Appendix FEIR-1

Draft EIR Comment Letters

RE: Hollywood & Wilcox Project – ENV-2016-3177-EIR
6430-6440 W. Hollywood Blvd.
Draft Environmental Impact Report (DEIR) – Metro Comments

Re: "Hollywood and Wilcox"

Alternative 5: Proposed Hollywood Community Plan Update Complaint Mixed-Use Alternative

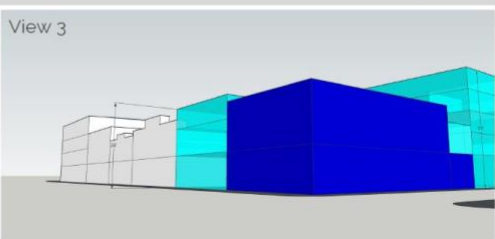
- Under the Proposed Hollywood Community Plan Update the project site would be designated a Regional Commercial Center with a zoning designation of C4-2D-CPIO with FAR limitation of 3:1 and max height of 75 ft
- Would retain but not restore the Attie
- 127,375 sqft of new use - 123 multi-family housing units (no workforce housing), 14,600 sqft for retail and 3,200 for restaurant, 14,375 open space
- New buildings between 1 and 7 stories, max height 75 ft
- 222 parking spaces, 1 subterranean level, .5 ground level and 1 above ground (no 10% reduction in parking compared to proposal)
- Would not seek certification under AB 900 Jobs and Econ improvement thru environmental leadership
- Does not say if they would keep 6434 Hollywood

HISTORIC RESOURCES	ZONING & USES	BUILT FORM	PUBLIC REALM
		MASSING By-Right: 45 feet & FAR 2:1 GBA: 119,109 sq ft Maximum Height: 55 ft	Density Bonus with Affordable Housing Resulting FAR 2.7:1 (Including Density Bonus) Includes open space along Wilcox
